Form C-103
Revised July 18, 2013

WELL API NO. 30-015-40890
5. Indicate Type of Lease STATE ☒ FEE ☐
6. State Oil & Gas Lease No. VG-3604-0062
7. Lease Name or Unit Agreement Name Lost Tank 35 State SWD
8. Well Number 1
9. OGRID Number 16696
10. Pool name or Wildcat SWD Delaware

SUNDRY NOTICES AND REPORTS ON WELLS
(DO NOT USE THIS FORM FOR PROPOSALS TO DRILL OR TO DEEPEN OR PLUG BACK TO A DIFFERENT RESERVOIR. USE "APPLICATION FOR PERMIT" (FORM C-101) FOR SUCH PROPOSALS.)

Lost Tank 35 St SWD 1 - Forward Plan

Current Well Status:

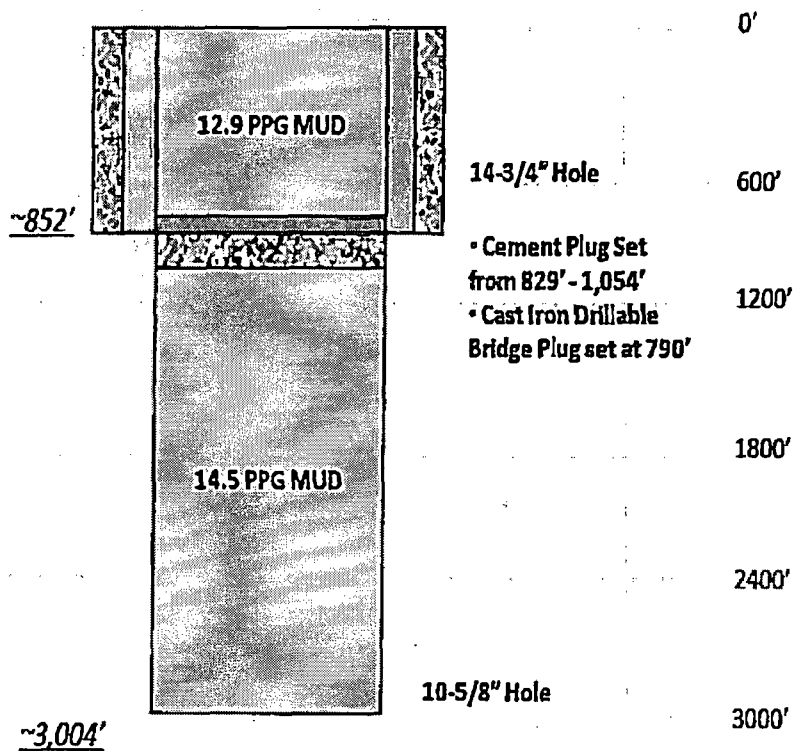
SUMMARY OF CHANGES:

Option 1 – Flex 3 using same wellbore (3 string if able to contain flow with casing drilling)

- Expand location for a Flex 3 w/ enough space for at least 5 additional frac tanks.
- Drill out CIBP and cement. If no losses/gains with the kill mud weight in the hole, casing drill 10 5/8" hole to ~4340' (100' into Lamar) and cement 9 5/8" 40# J55 UFJ casing. Drill 8 3/4" hole to TD of ~6320' and set 7" 26# L80 LTC casing.

Option 2 – Flex 3 using same wellbore (4 string if unable to contain flow with casing drilling)

- Expand location for a Flex 3 w/ enough space for at least 5 additional frac tanks.
- Drill out CIBP and cement. Casing drill 10 5/8" hole to ~3200' and cement 9 5/8" 40# J55 UFJ casing to isolate flow, in the scenario where losses are experienced with the 14 ppg mud, or if H2S levels raise above the HES limits. Drill 8 3/4" hole to ~4340' (100' into Lamar) and set 7 5/8" 26.4# J55 UFJ casing. Drill 6 3/4" hole to TD of ~6320' and set 5 1/2" 17# L80 BTC casing.

Option #1

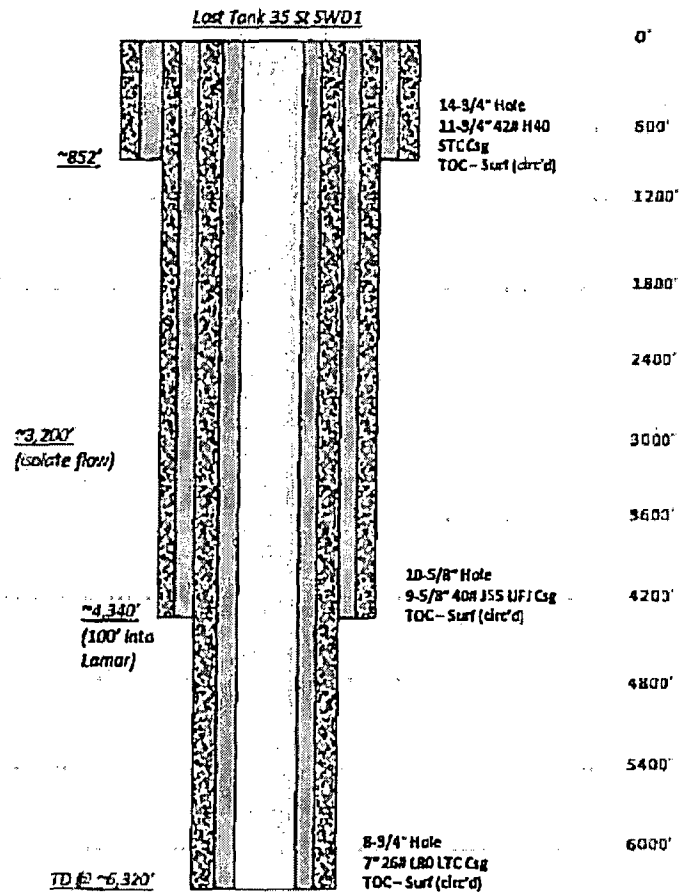
If able to control flow with casing drilling:

- Casing design
 - 9 5/8" 40# J55 ULT-FJ
 - 7" 26# L80 LTC
- Wellhead
 - Cameron MBS
- Centralizers/Float Equipment
 - Davis-Lynch
 - 9 5/8" FE available (oxy owned)
 - Wear Sox Centralizers
- Expand location
- Drill mousehole

Option #2

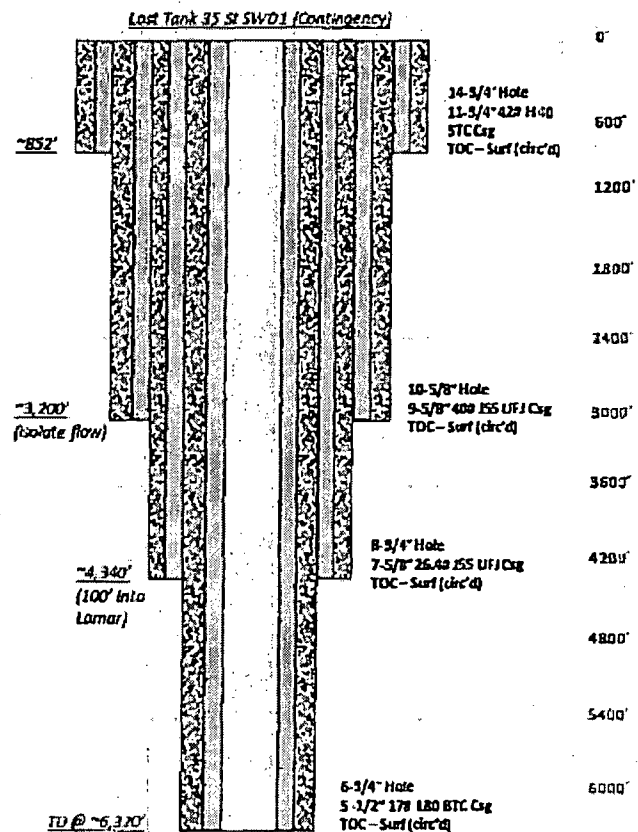
If unable to control flow with casing drilling:

- Casing design
 - 9 5/8" 40# J55 ULT-FJ
 - 7 5/8" 26.4# J55 ULT-FJ
 - 5 1/2" 17# L80 BTC
- Wellhead
 - Cameron MBS
- Centralizers/Float Equipment
 - Davis-Lynch
 - 9 5/8" Float Eq available (oxy owned)
 - Wear Sox Centralizers
 - Weatherford
 - 7 5/8" Float Eq
(Currently being thread for Ult-FJ)
- Expand location
- Drill mousehole
